ADDENDUM NO. 2

Issue Date:	January 17, 2024
Project Name:	Sandridge Golf Club New Clubhouse
ITB Number:	2024029
ITB Opening Date:	**February 1, 2024**

This addendum is being released to provide answers to questions received to date, modify the bid documents, provide additional background documents, and provide minutes to the pre-bid meeting.

SHEET NUMBER
A 503

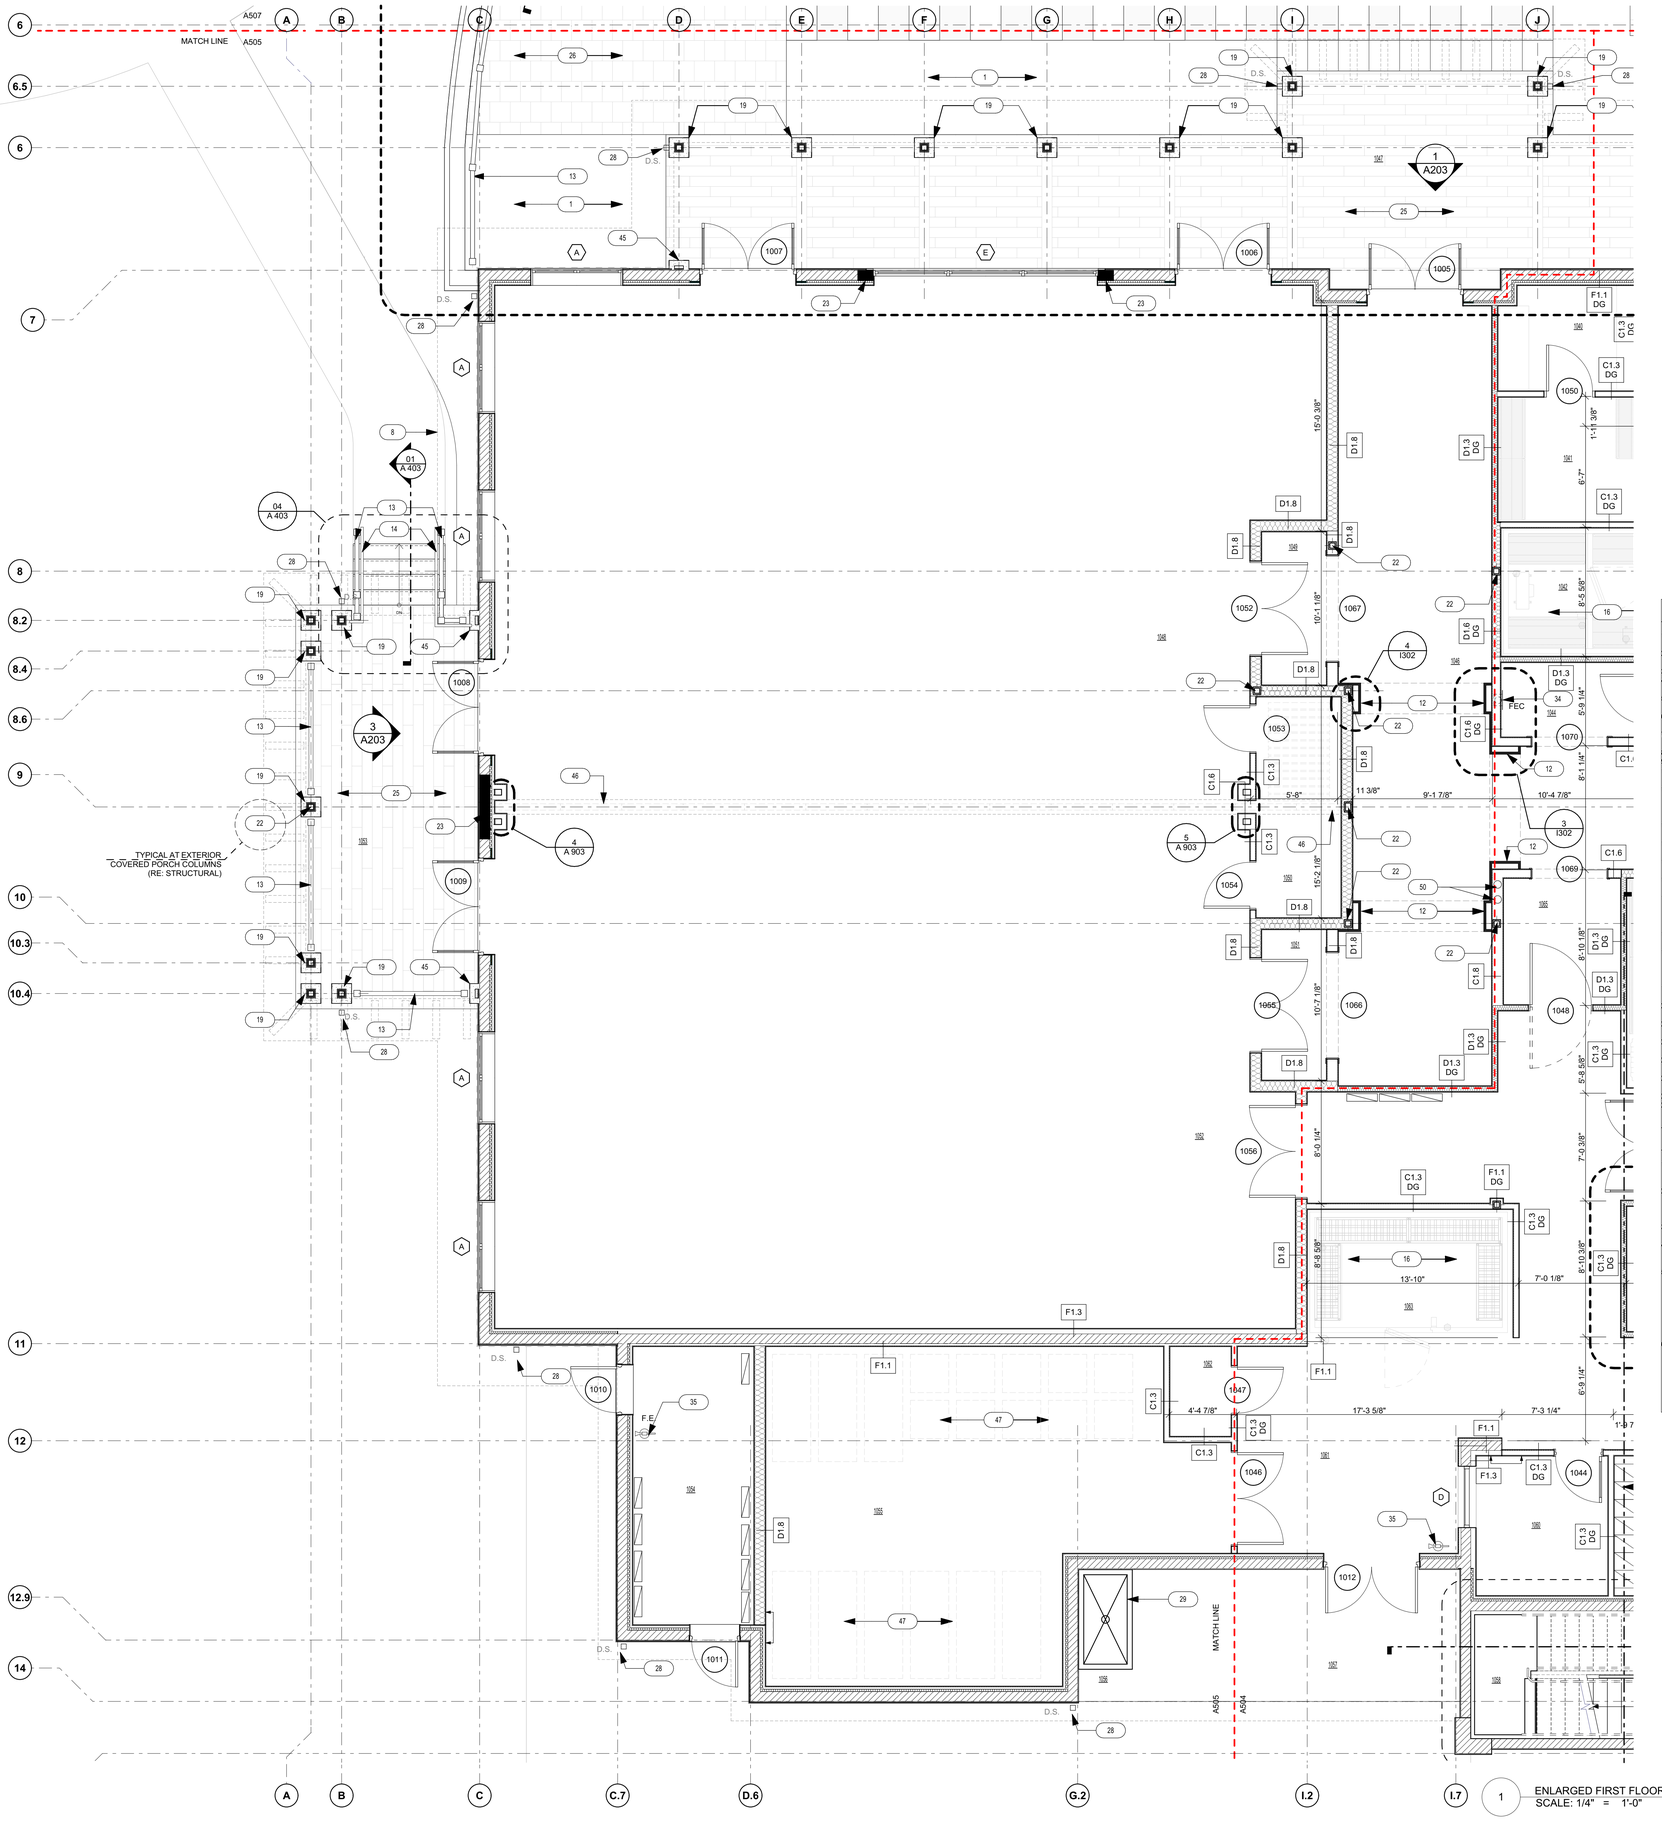
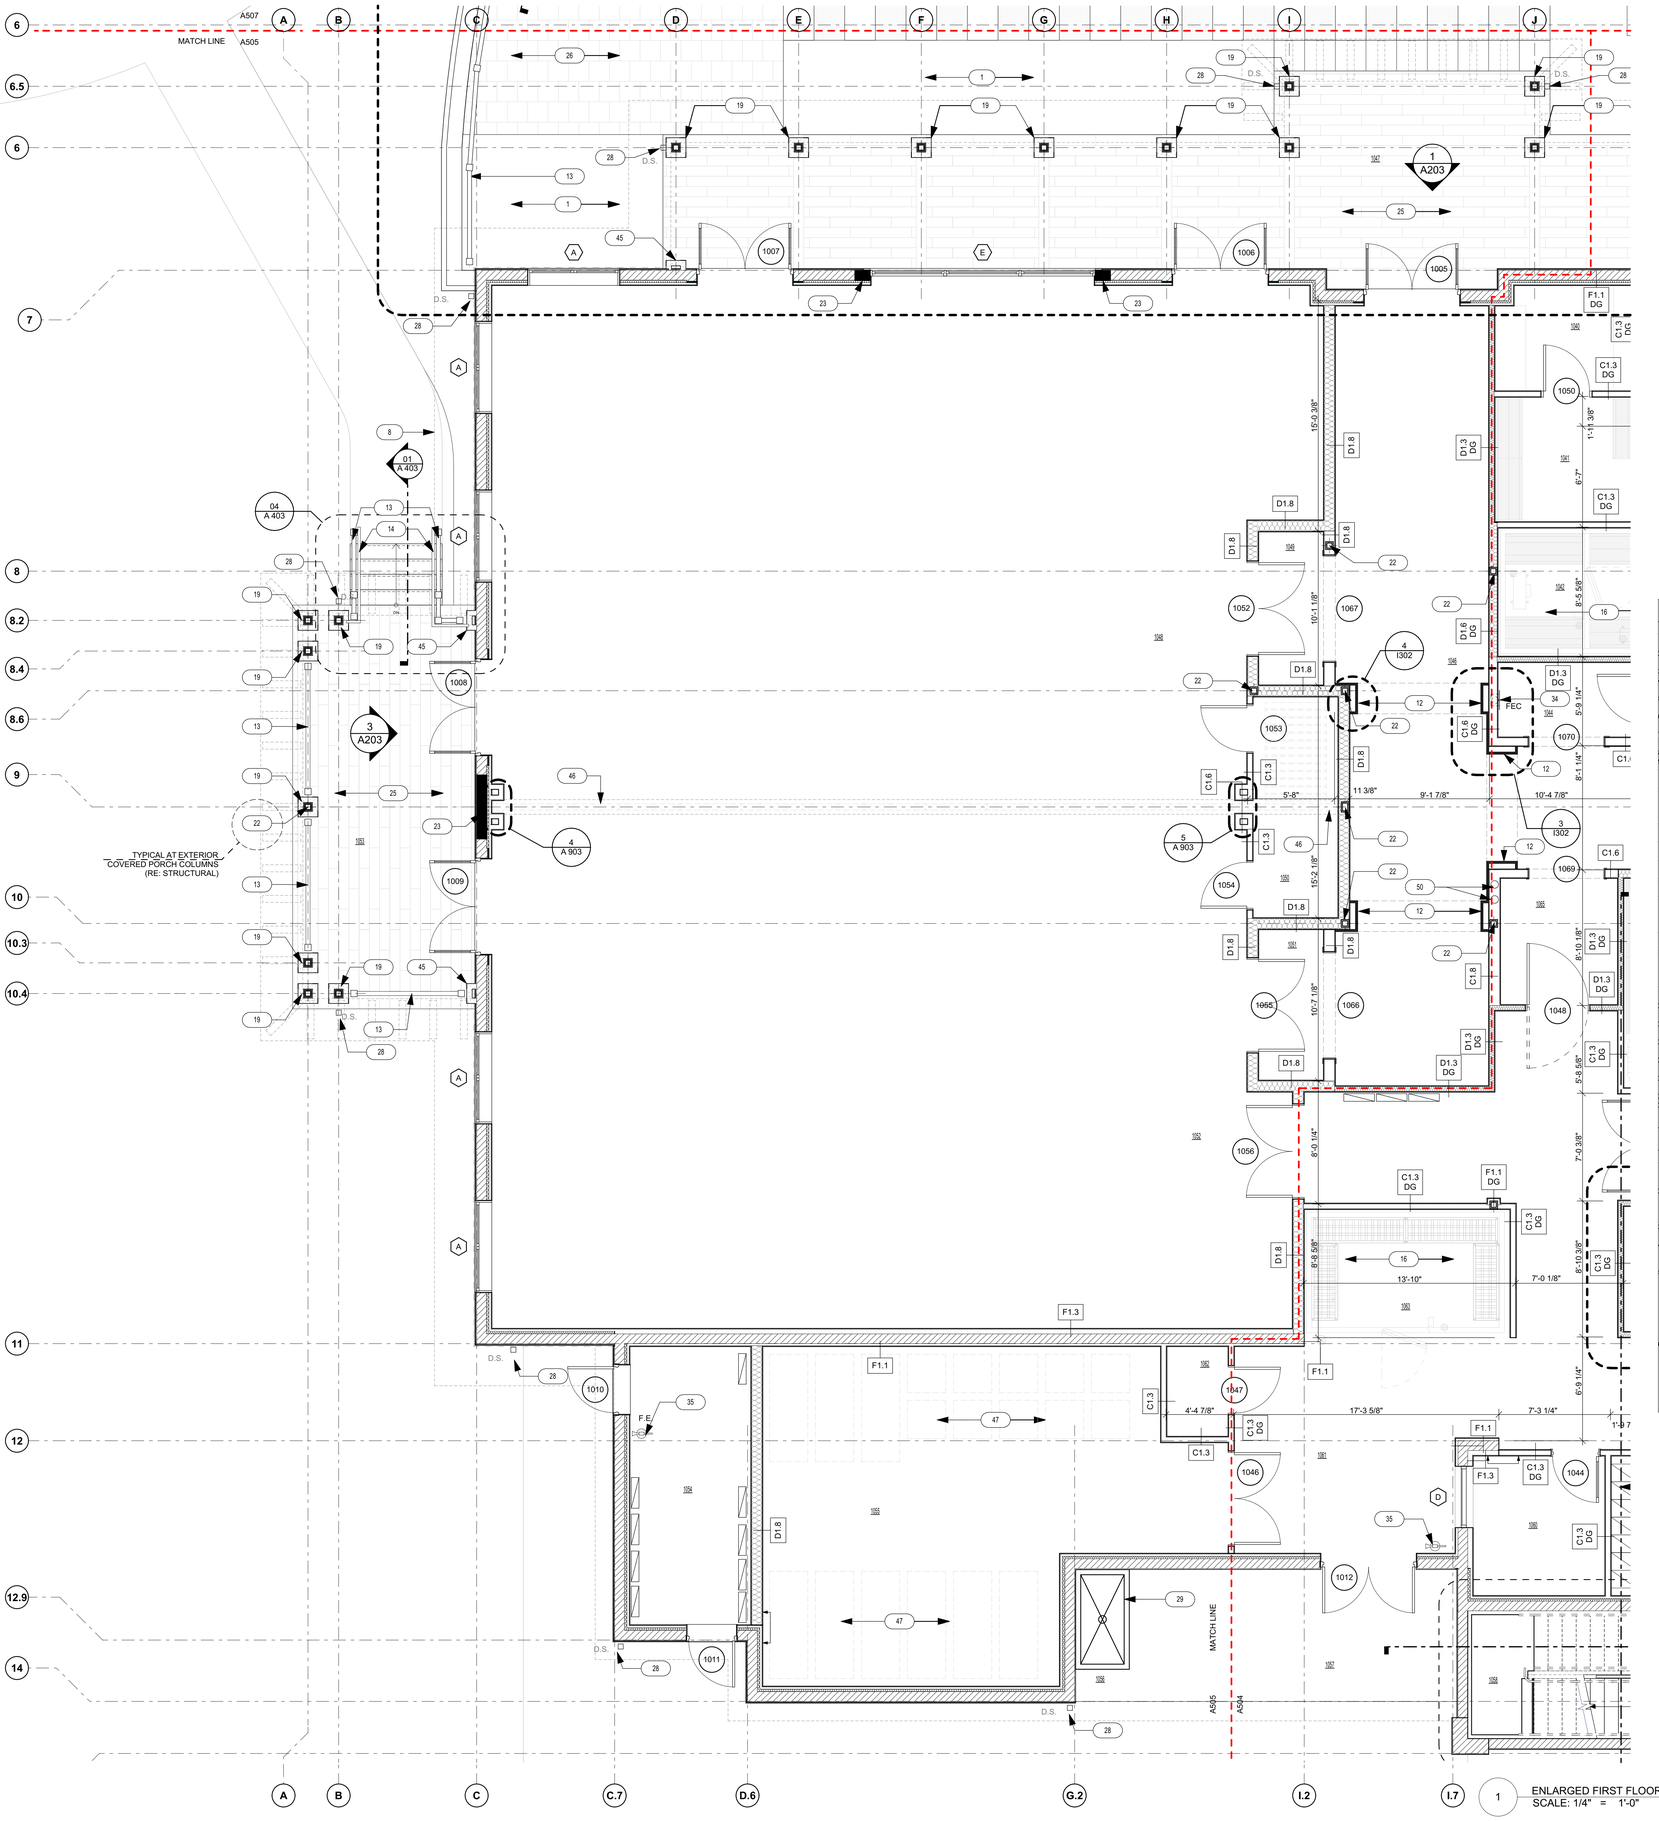
2. DRAWING A-505 WINDOW TYPE IS MARKED WITH AN (A) I BELIEVE IT SHOULD BE LABELED AS AN (E) ACCORDING TO THE WINDOW SCHEDULE. PLEASE VERIFY
Confirmed, the window type mark is updated on Sheet A-505. See revised sheet.

12. SHEET A503 SHOWS A MATCHLINE PAGE A-510 THERE IS NO SUCH SHEET PLEASE ADVISE.
Matchline page A-510 is revised to A-507. See revised sheets A503 and A505 for clarification.

1 A605 ENLARGED FIRST FLOOR RCP
SCALE: 1/4" = 1'-0"

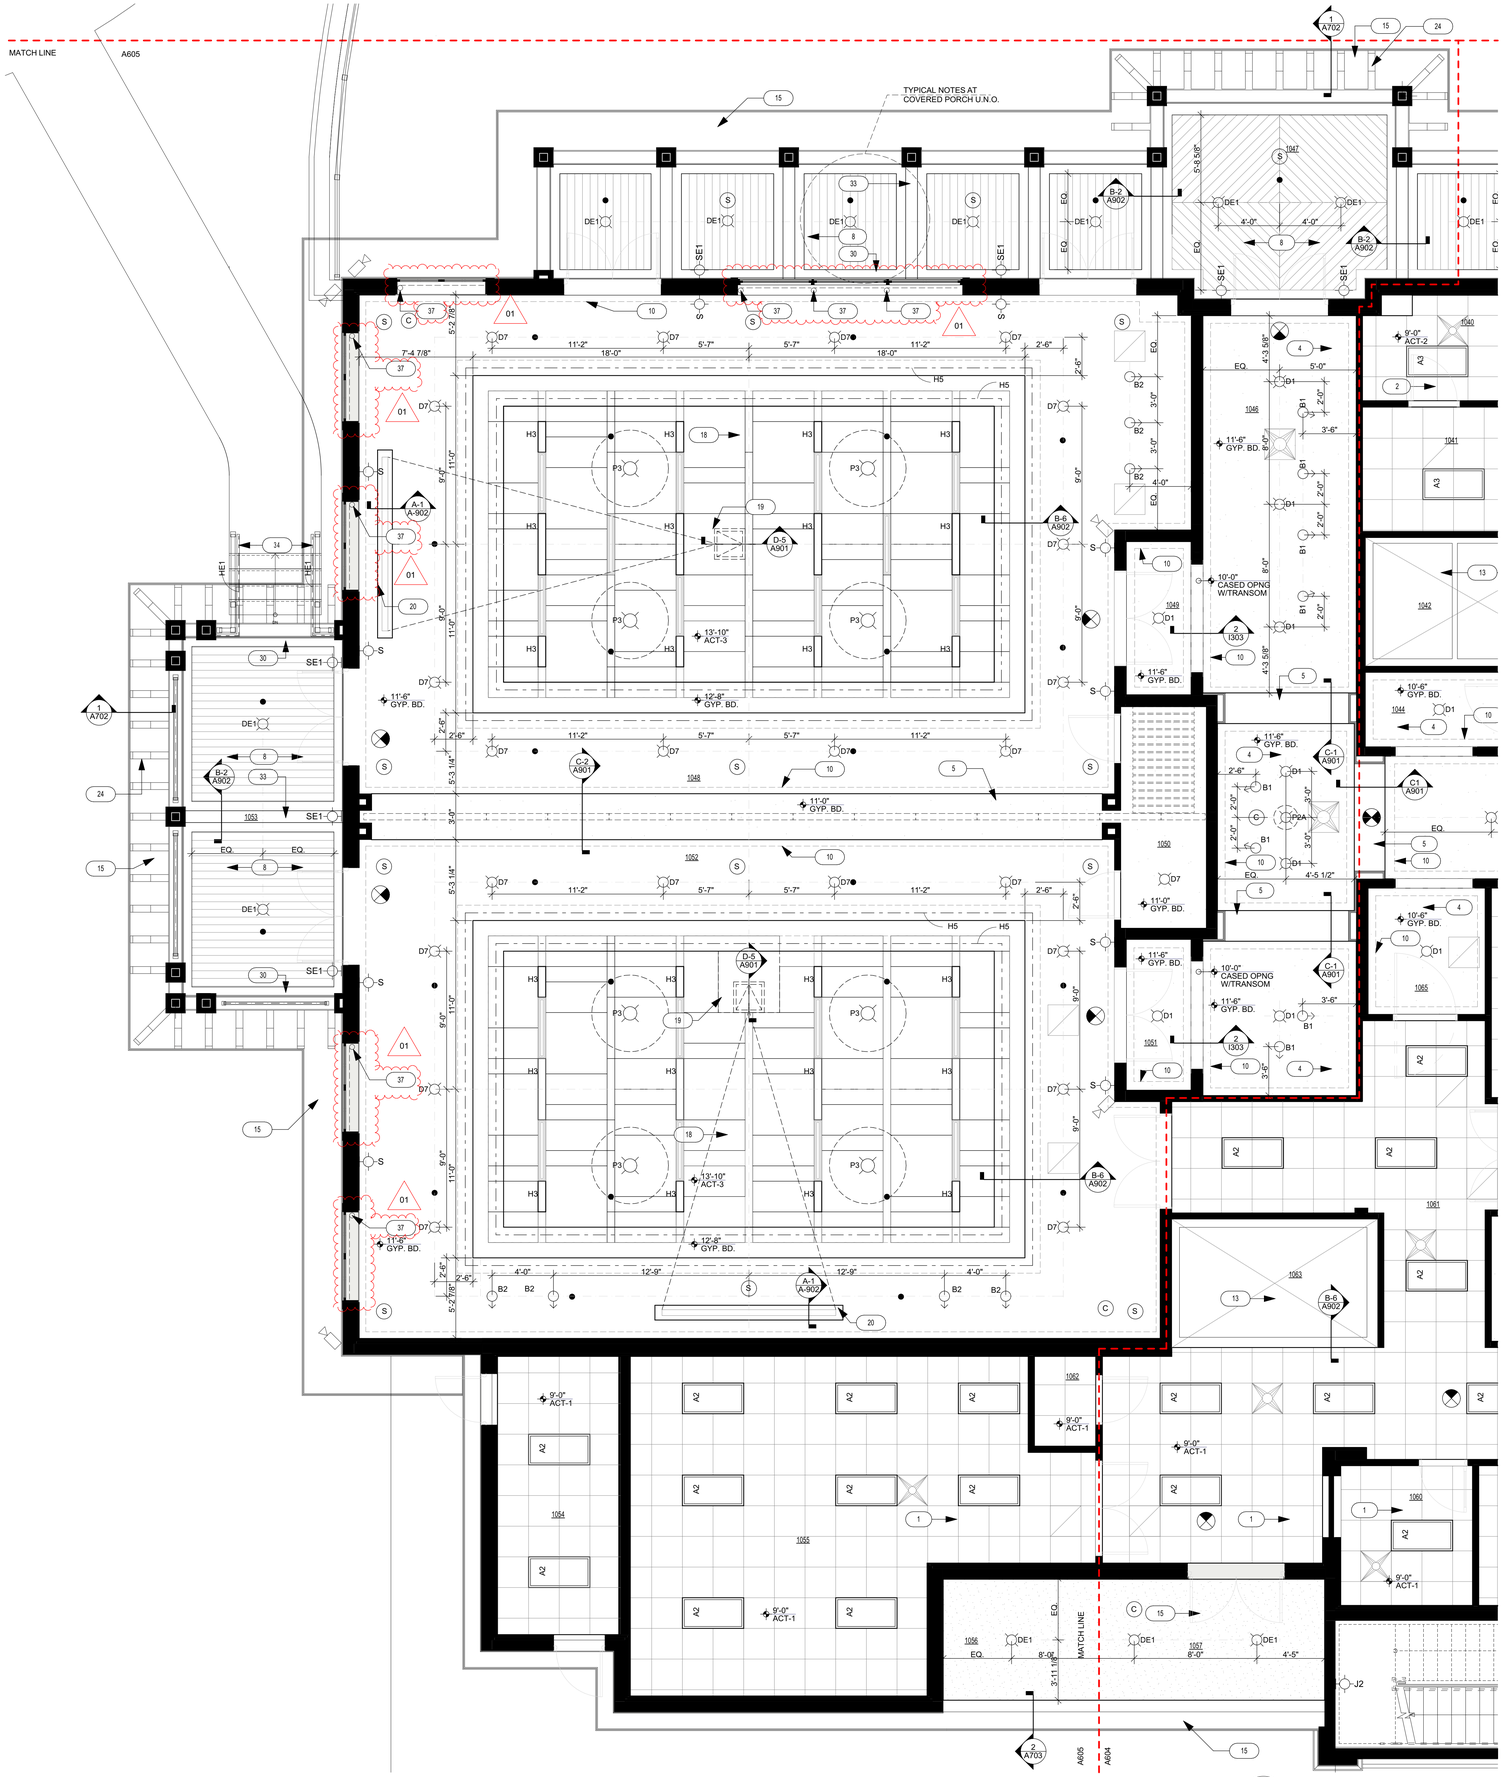
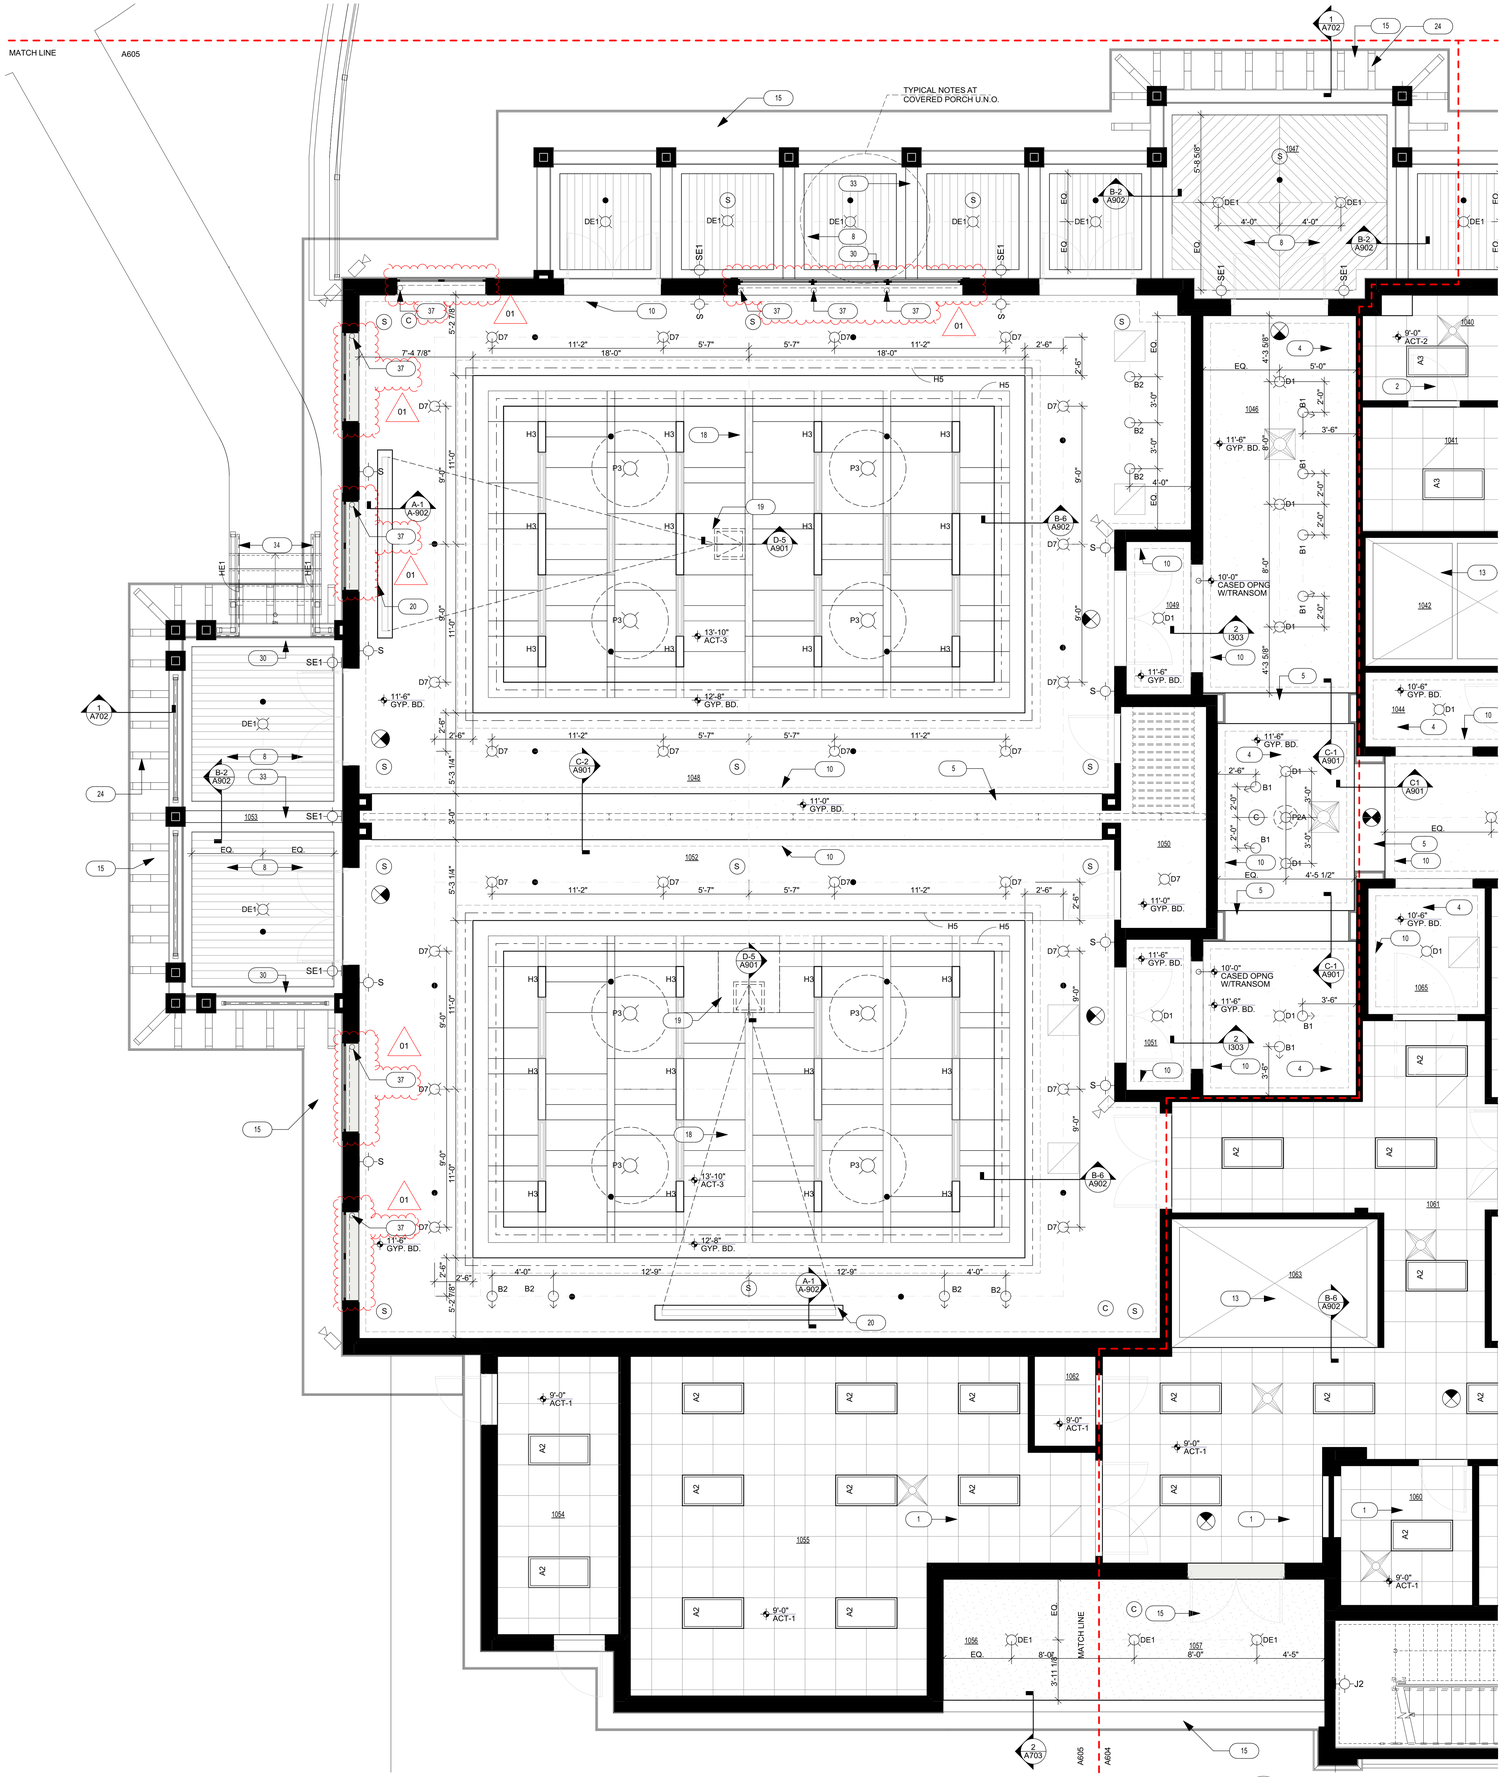
15. PLEASE CONFIRM THE ROLL DOWN MOTORIZED SCREENS ARE BY OWNER.
Roll down motorized screens are contractor furnished/contractor installed. See revised sheets A411, A605, A805, I216 and I217 for additional information.
